### HISTORIC AND DESIGN REVIEW COMMISSION

HDRC CASE NO: 2016-153 ADDRESS: 204 WICKES

**TYPE OF WORK:** Construction of a front porch

The applicant is requesting a Certificate of Appropriateness for approval to construct a full width front porch at 204 Wickes.

1 FRONT VIEW

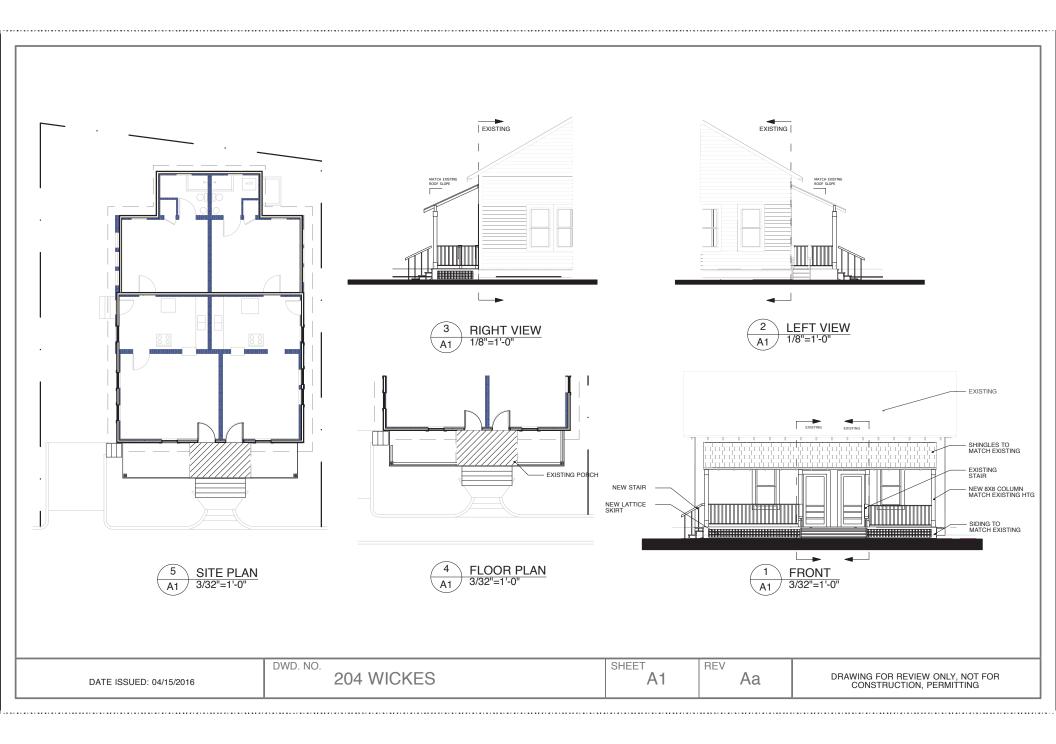
- c. The applicant has proposed to construct a full width front porch with a total depth of twelve (12) feet, the depth of the existing front stoop. The applicant has noted that the existing stoop will remain. Staff finds the applicant's proposed porch depth appropriate.

- d. In regards to detailing and materials, the applicant has proposed to use asphalt shingles to match the existing, wood siding to match the existing, simple wood railings, wood lattice skirting and 8" x 8" wood columns. The applicant has proposed for the porch's roof slope to match that of the original structure, however, the roof will extend from beneath the original structure's roof overhang. Staff finds both the applicant's proposed materials as well as the proposed roof form appropriate.

- e. Staff finds that the proposed front porch design is one of simple detailing and includes elements that do not

detract from the architectural integrity of the structure at 204 Wickes or the integrity of the surrounding historic structures. Staff finds the applicant's proposal appropriate.

Staff recommends approval as submitted based on findings a through e.
